LBNF CAD check

A crosscheck of the LBNF CAD model (ST1294927_01, August 2020) is done to verify if the changes described in document EDMS 2194738 have been implemented: <https://edms.cern.ch/document/2194738/>

1. Corner haunch connection

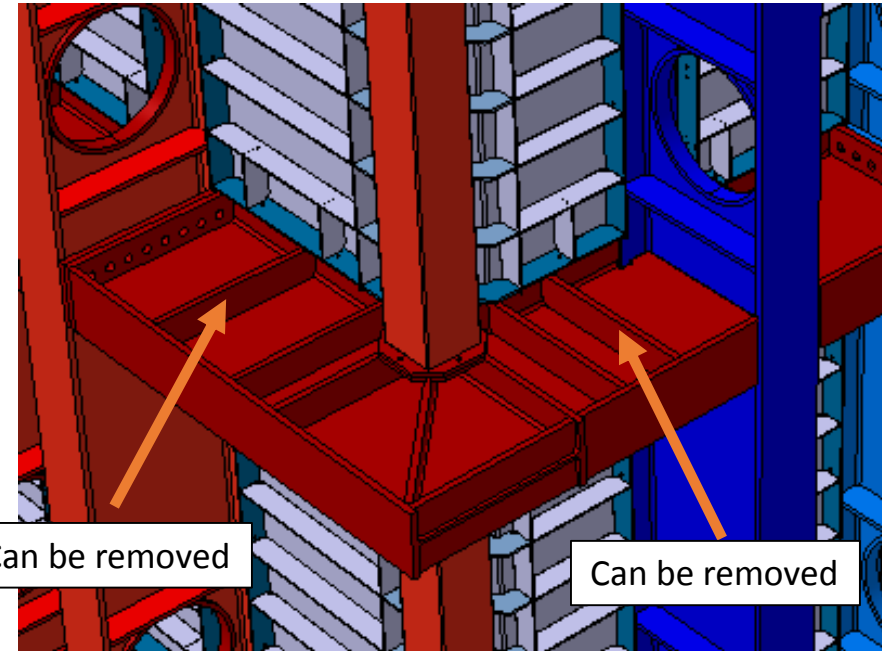
- Reinforcement plates removed from the corner → **OK!**
- Extra stiffeners have been left after removing they plates → **Extra stiffeners may be removed**

4. Changes to the floor

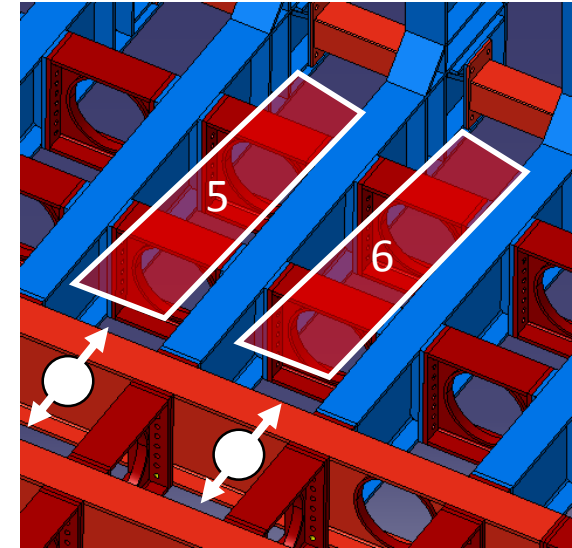
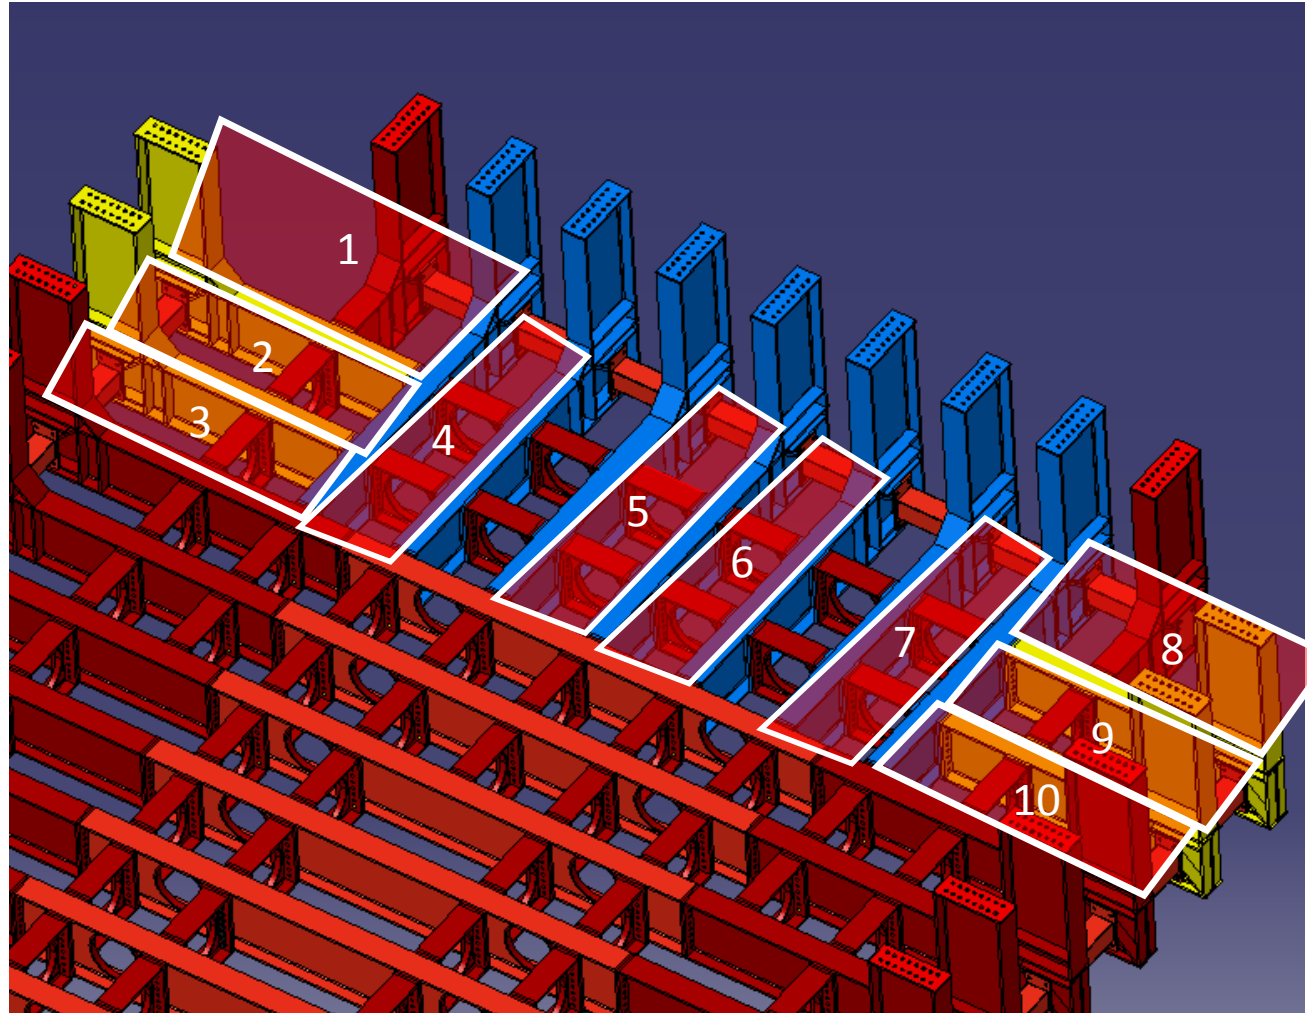
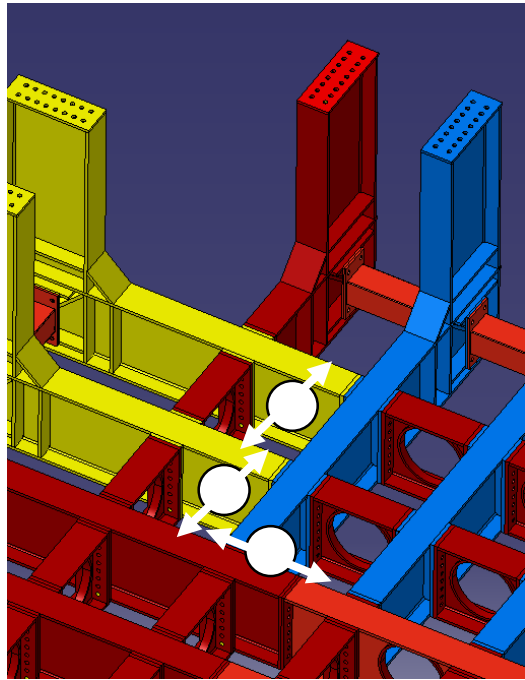
- The following sections are not accessible from the central floor through openings → **Not a structural issue. If access is needed, it should be placed in the locations shown below (white circles). Openings in these locations were calculated in EDMS 2308165.**

4. Changes to the floor

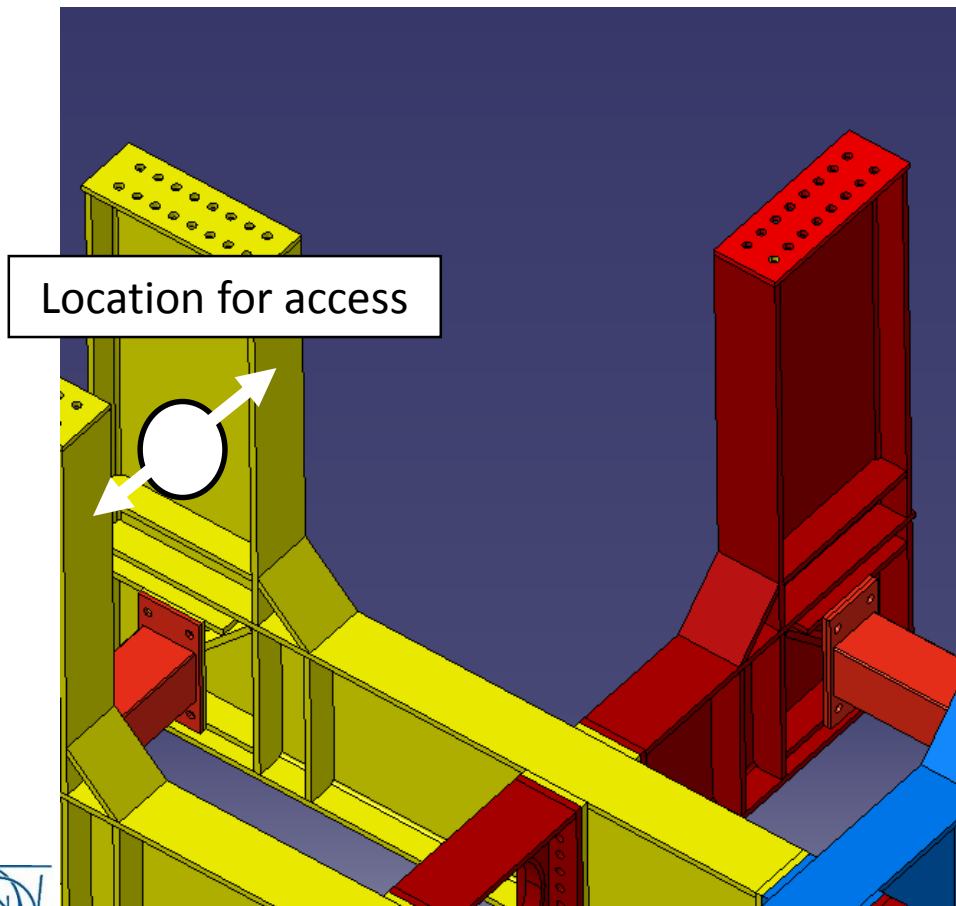
- Similarly the corners of the cryostat are not accessible → **Access should be placed in the vertical portion of the yellow beam, in case it is needed.** (Openings in this location was calculated in EDMS 2308165.)

6. Welded connections – Belt 2 corner

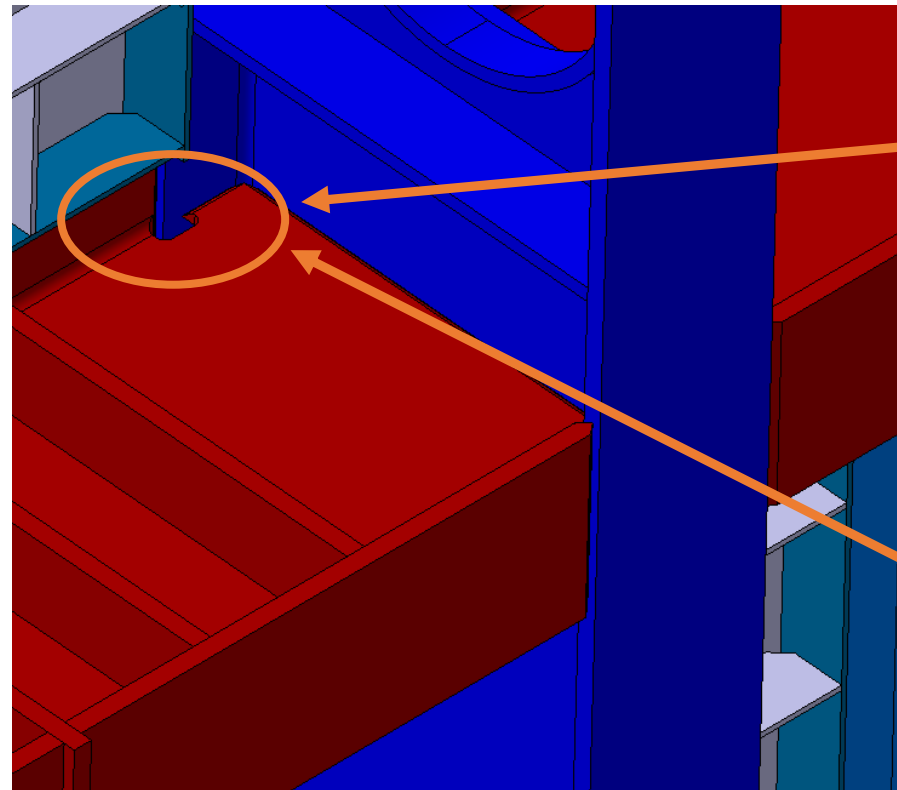
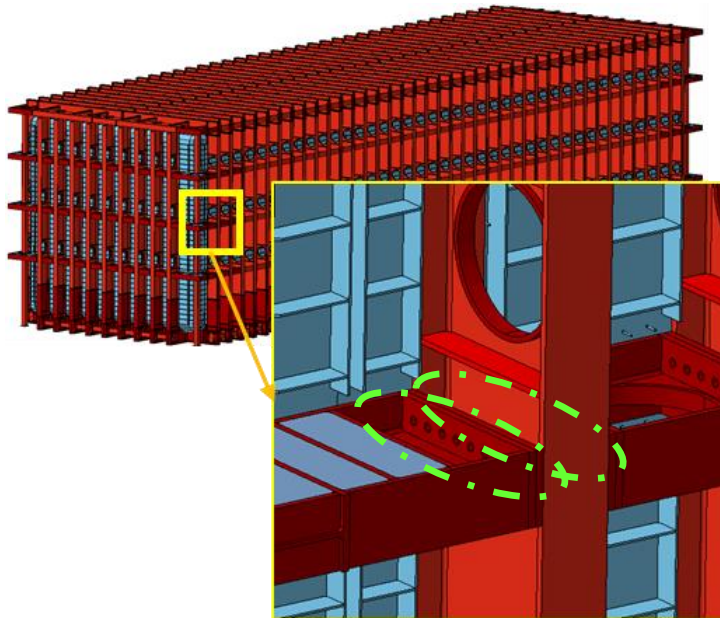
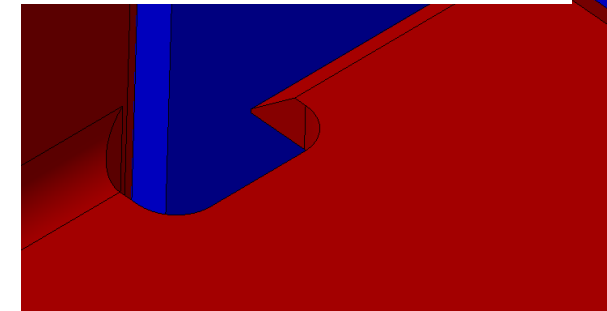
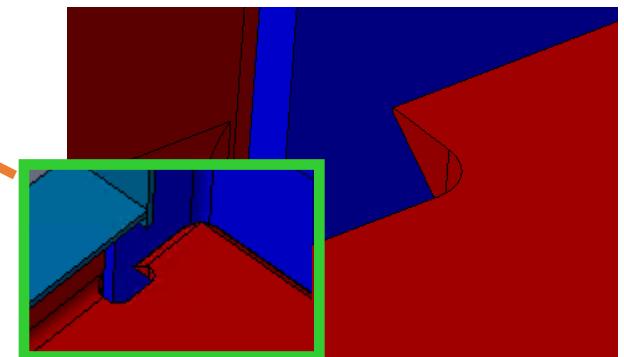
- Welded connections are included on the belt 2 corners in the correct positions. 8 welded connections in total → OK!
- Weld chamfers are on the wrong side on two corners → **Check that the orientation of chamfers is correct**

Chamfer towards top (in 2 corners)

Chamfer towards bottom (in 2 corners)

7.a) Warm membrane: wall plates

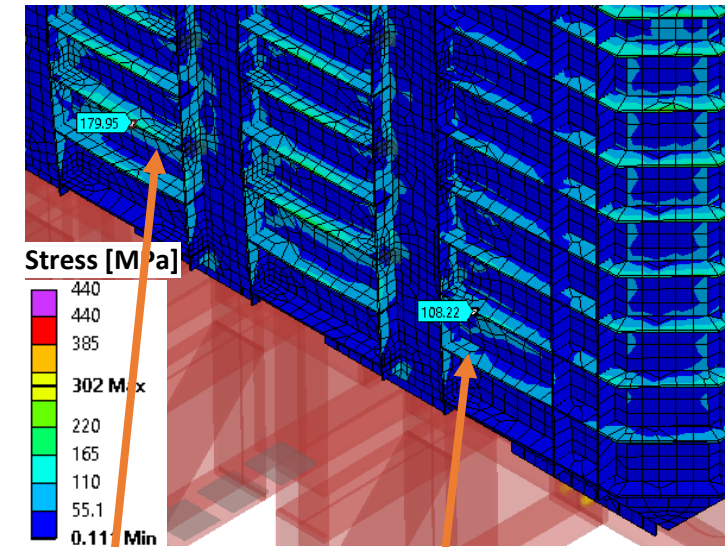
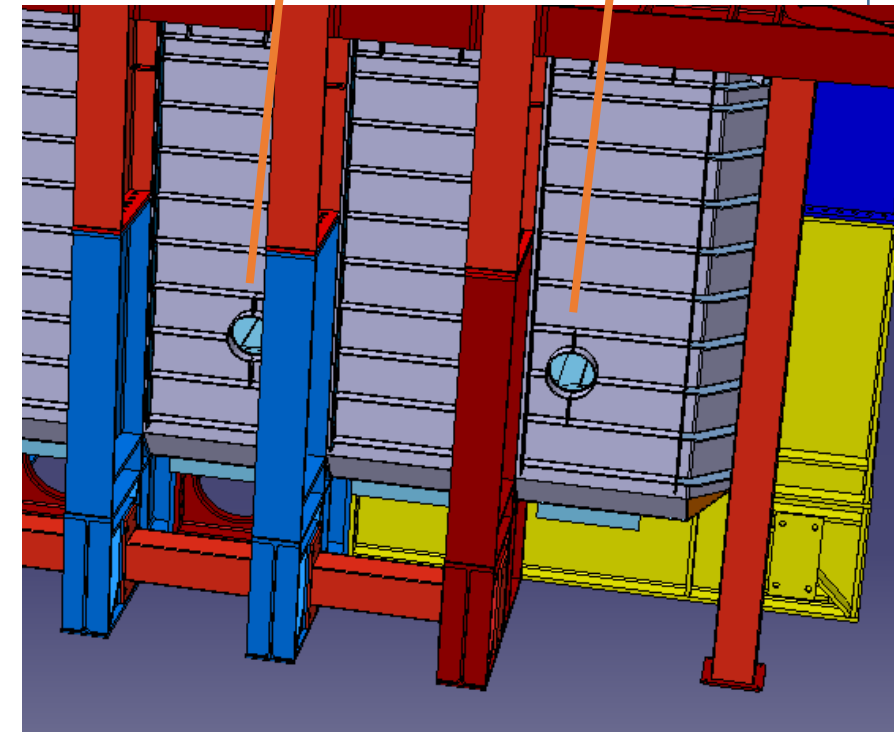
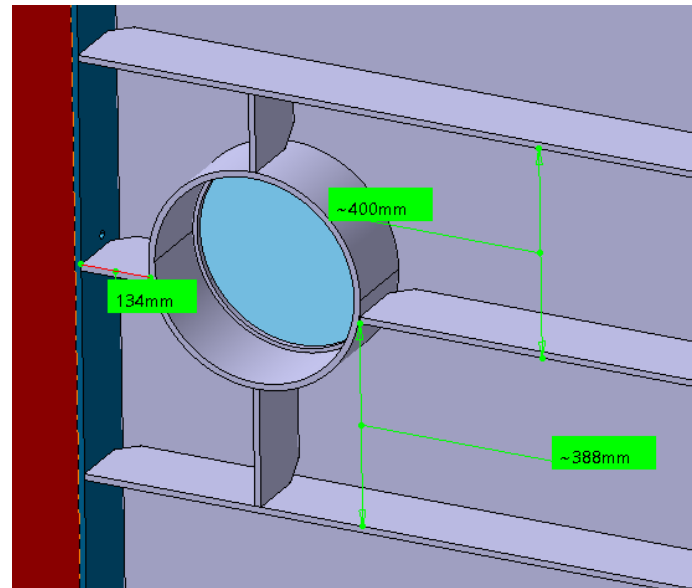
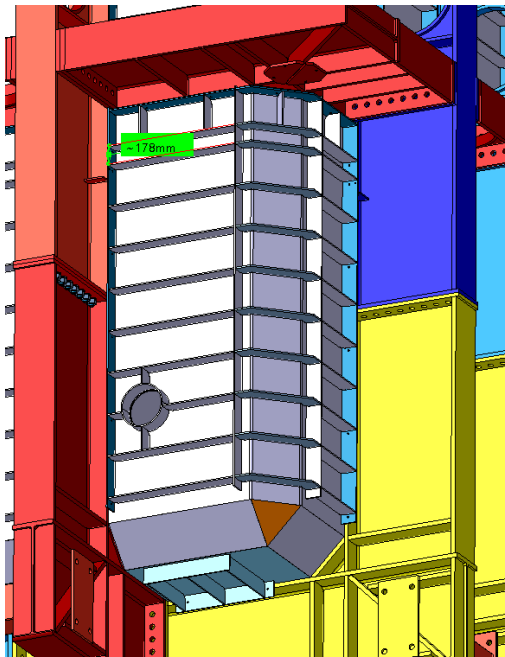
- Any local changes to the ribs respects the maximum rib pitch of 400 mm → **OK!**
- Local changes in ribs are not checked by calculations. Significant stresses are present on the ribs (Max ~180 MPa) → **It is recommended to check the strength and stiffness of the local changes.**
- **It is also recommended to consider the effects of membrane deformations on the feed-through.**

7.c) Warm membrane: Floor and Roof corners

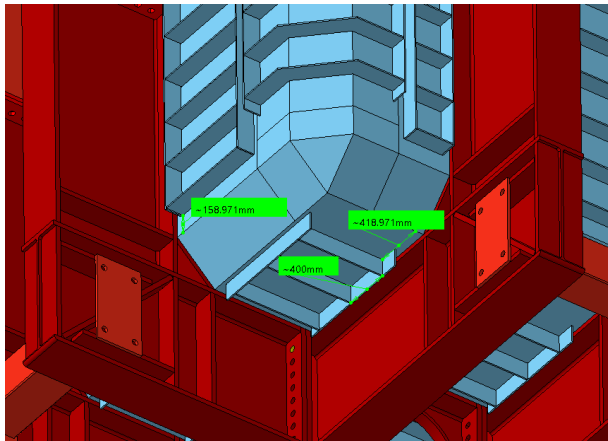
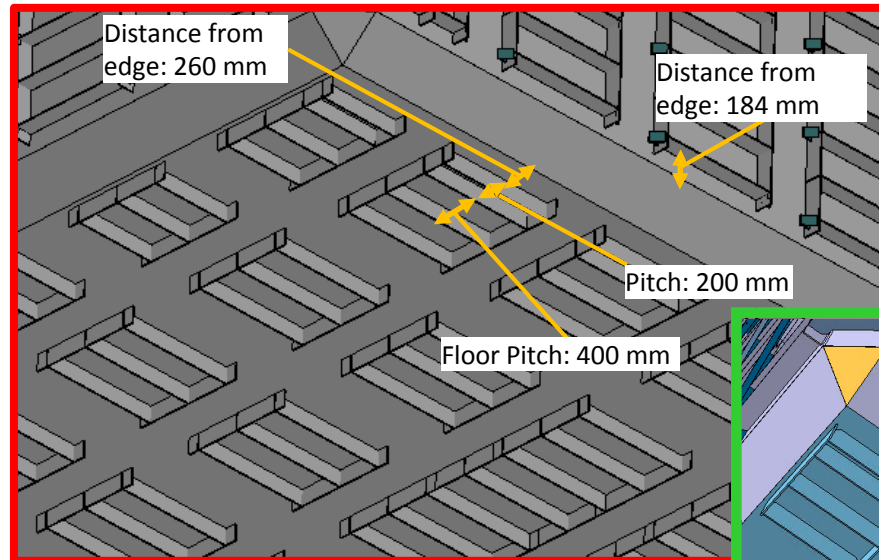
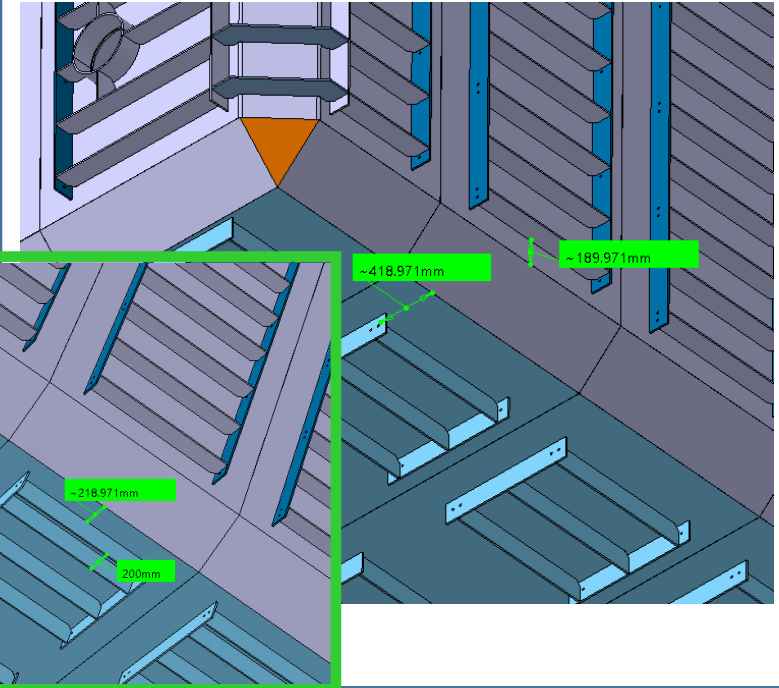
- Extra ribs have not been placed close to the membrane corners → **To be added according to calculation. See new concept below.**
- Holes for clamps for the insulation negative gauge pressure have been added to the correct positions → OK!

7.d) Warm membrane door

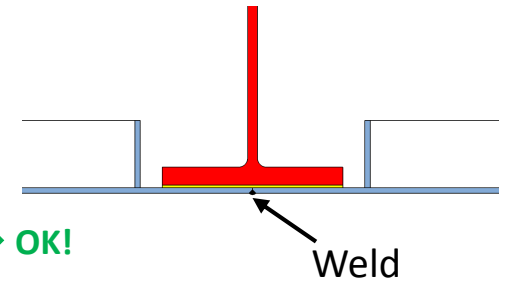
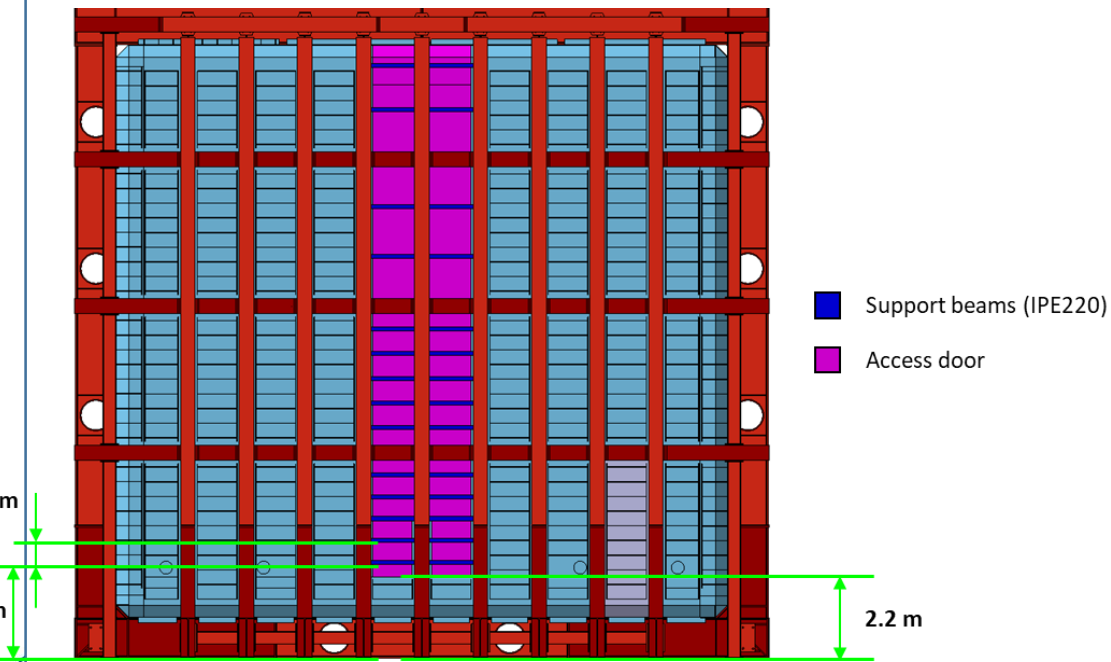
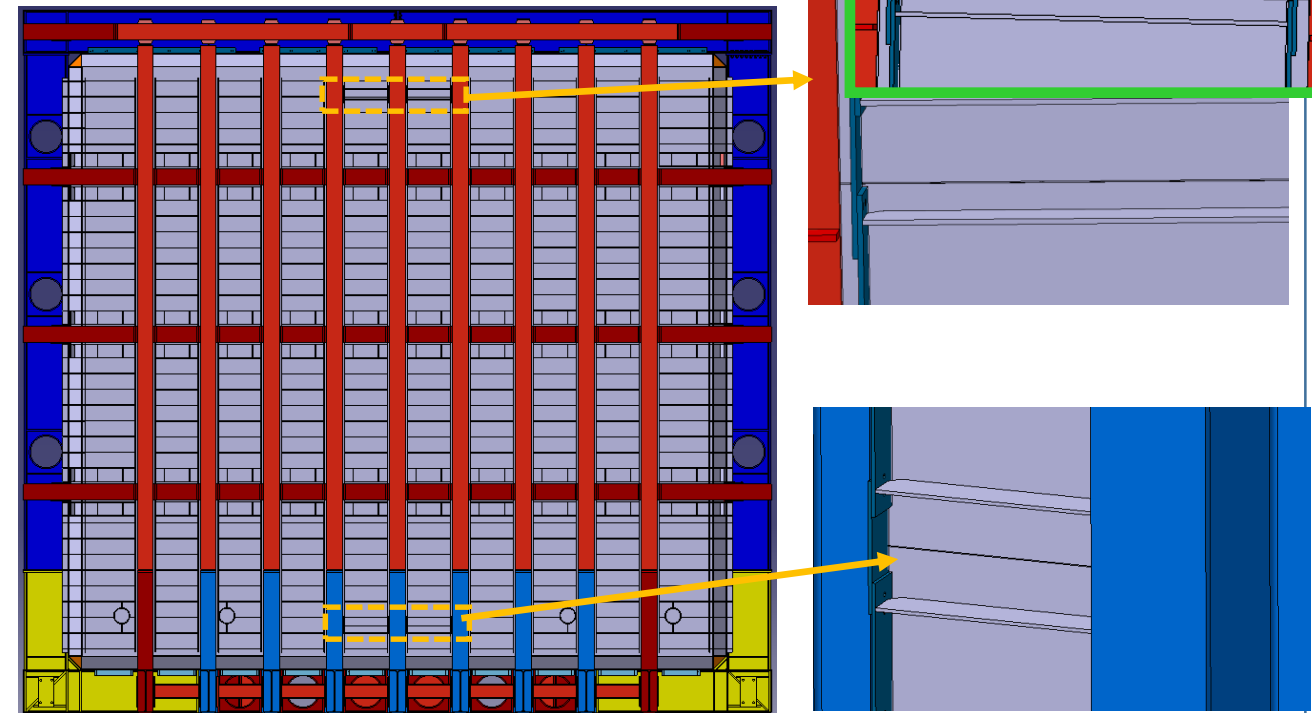
- The membrane door concept with IPE220 beams has been replaced with a standard welded door like the wall plates → **OK!**
- Weld of the door is not offset from the I-beam centerline, although the possibility was discussed?
- Some gaps or misalignment seems to be present → **Check alignment/dimensions of door plates in the CAD Model**
